COLERAIN TOWNSHIP BOARD OF ZONING APPEALS
Regular Meeting
4200 Springdale Road - Cincinnati, Ohio 45251
Wednesday, October 24, 2018 – 6:30 p.m.

Staff Report:	Board of Zoning Appeals
Case#	BZA2018-010
Variance Request:	Multiple for Redevelopment
Location:	10140 Colerain Ave.
Meeting Date:	October 24, 2018
Prepared by:	Marty Kohler Senior Planner

Re: Car Connections Zoning Variance Application

LANDSCAPE & LIGHTING PLAN

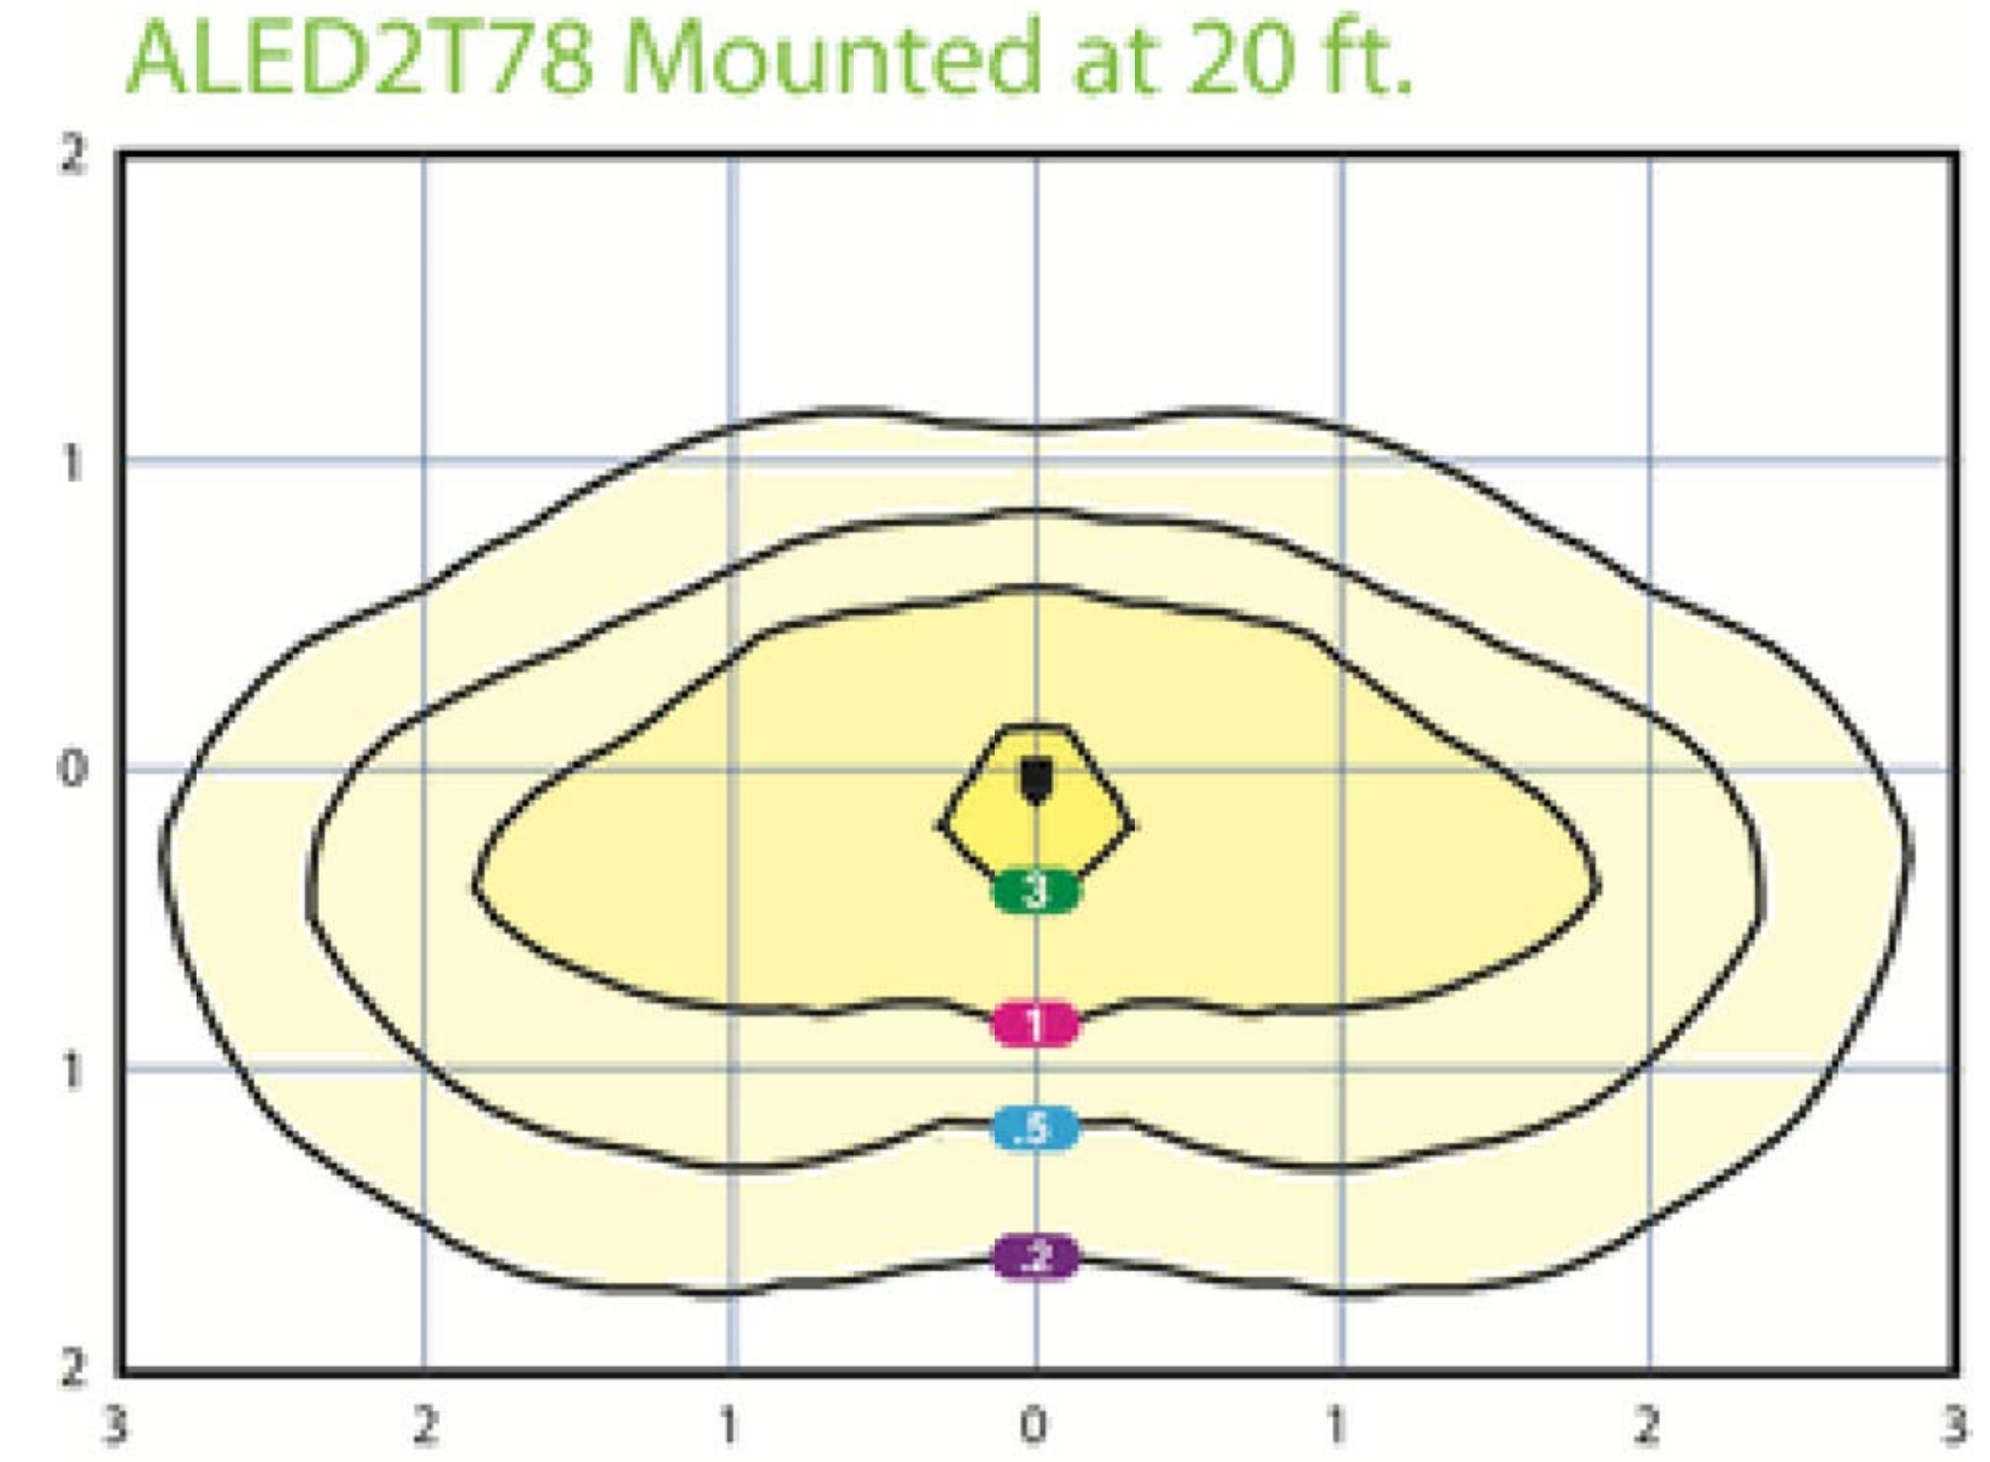
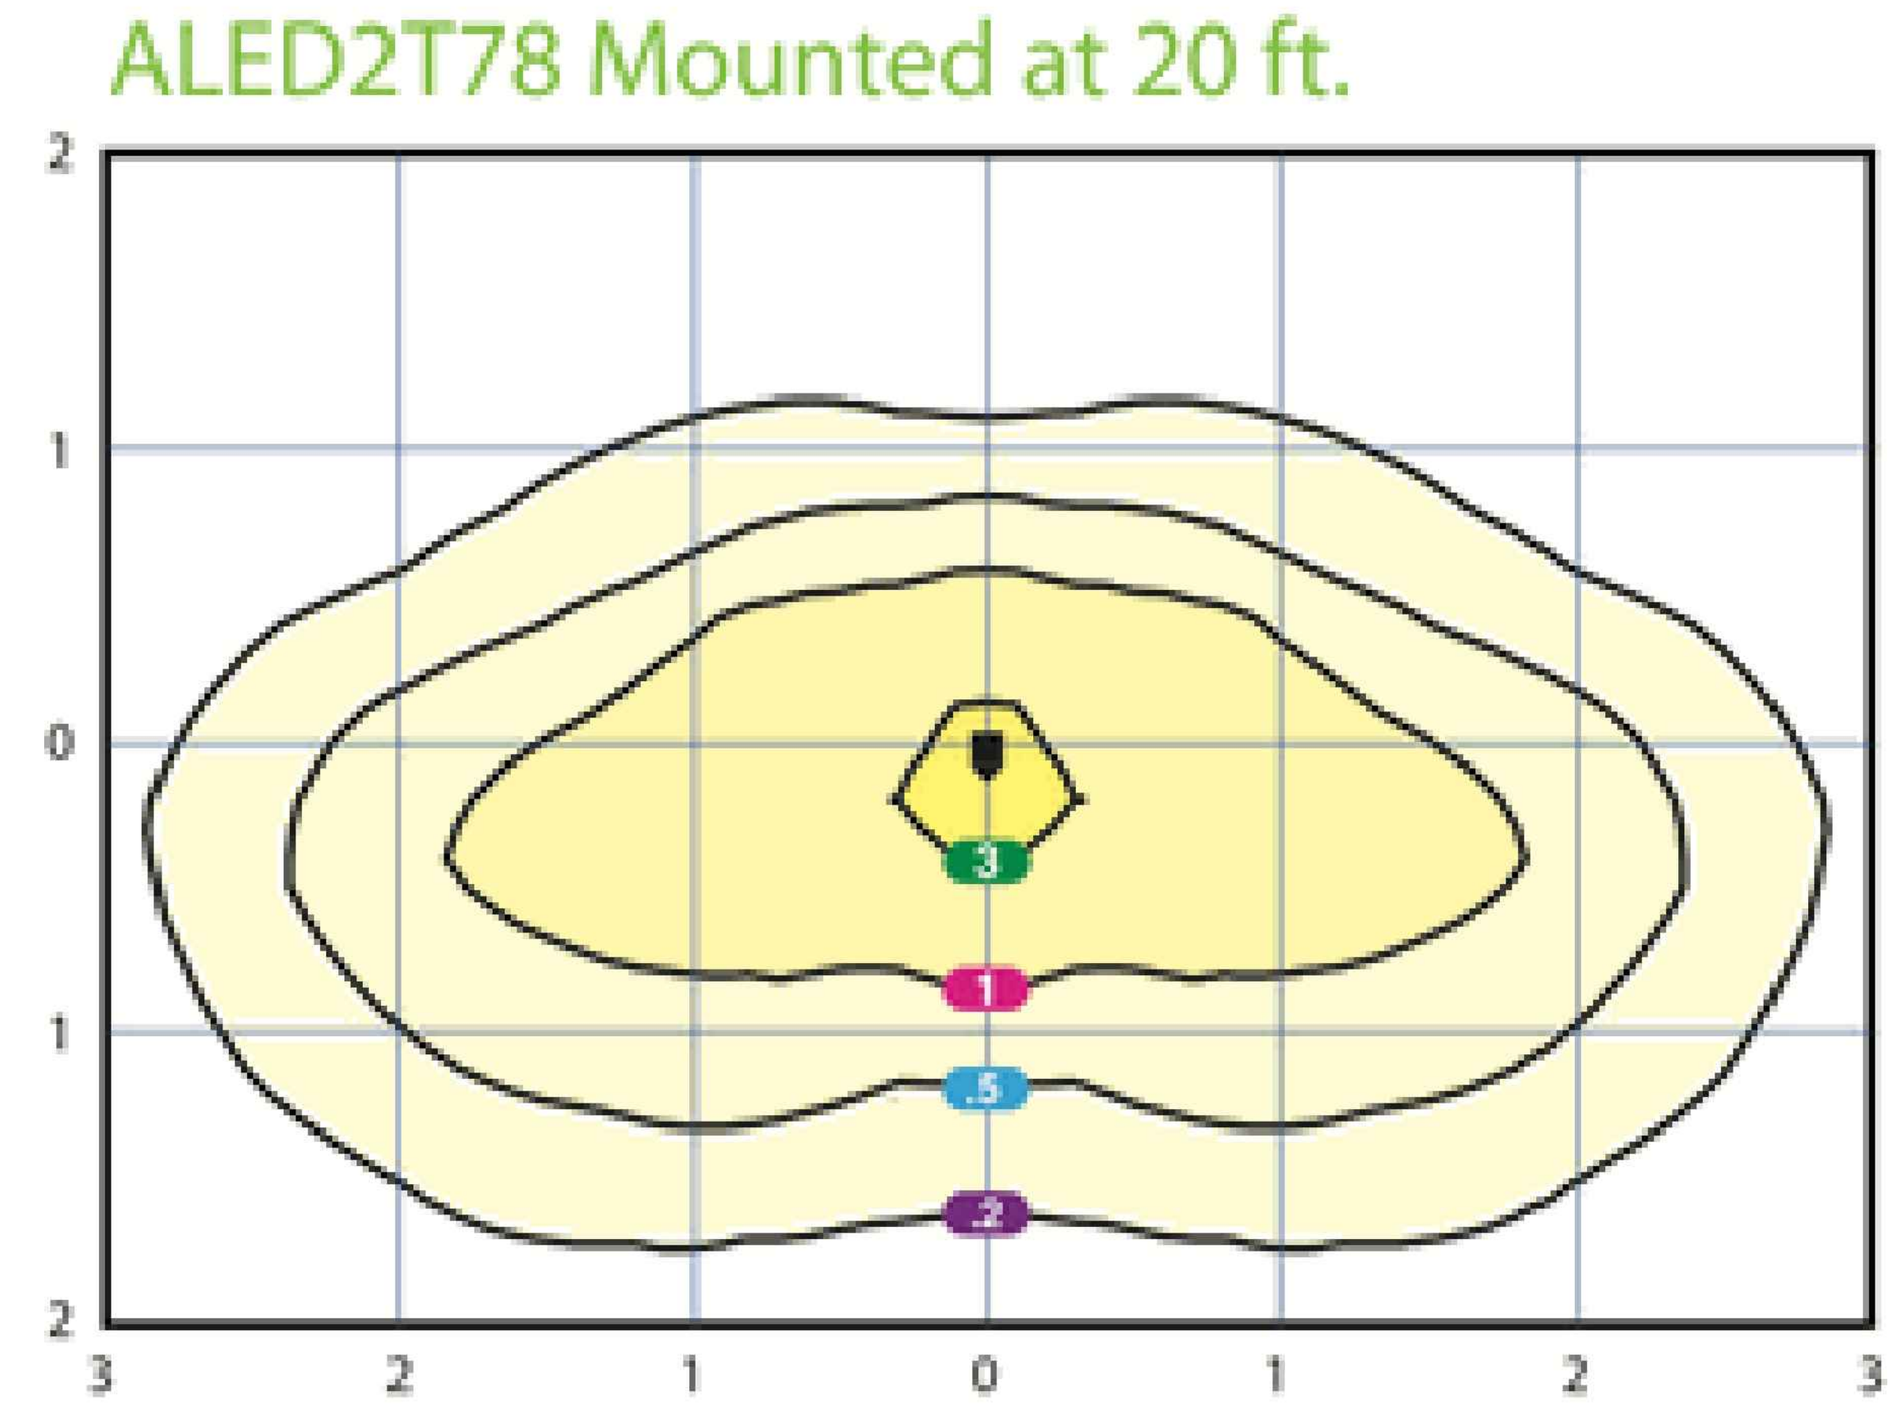
Section 14.6.2(A) - A landscape island is required at the end of each row of parking including the parking along the street frontage. None are proposed. The variance request is for the elimination of this requirement. ***Landscape islands have been added at the ends of the parking spaces facing Colerain Ave. at 75 square feet each and a width of 5 feet. Section 14.6.2(A) requires a minimum size of 135 square feet each (60 square foot variance request) and Section 14.6.2(F) requires a minimum width of 9 feet (4 foot variance request). In addition, since the customer parking has been relocated to the front of the building, a landscape island is required at both ends of that row of parking and none is provided.***

Section 13.4.1 and 14.5.1 requires that the parking area have a 15-foot setback from the right-of-way and that the setback include landscaping. No setback of the parking from the right-of-way is proposed. The variance request is for the elimination of this requirement. ***A 2 foot 6 inch wide buffer strip has been added across the front of the property with shrubs indicated. Two canopy trees or three ornamental trees are required for this buffer strip and none are proposed. The variance request is for a 12 foot 6 inch reduction in the buffer strip width and elimination of the tree requirement for this section of buffer strip.***

2. The requirements for minimum widths of green buffer strips is to help assure that the plant material will have enough soil and rainwater penetration to survive. Staff questions if the proposed buffer strips will support thriving vegetation. The three trees proposed at the rear of the property are intended to serve as a substitute for trees along the right-of-way.

APPROVAL OF THE VARIANCE REQUEST FROM SECTIONS 13.4.1 AND 14.5.1 TO REDUCE THE MINIMUM WIDTH OF THE STREETSCAPE BUFFER FROM 15 FEET TO 2 FEET SIX INCHES ON THE CONDITION THAT THE REQUIRED TREE PLANTING IN THE BUFFER STRIP BE ACCOMMODATED ELSEWHARE ON THE SITE.
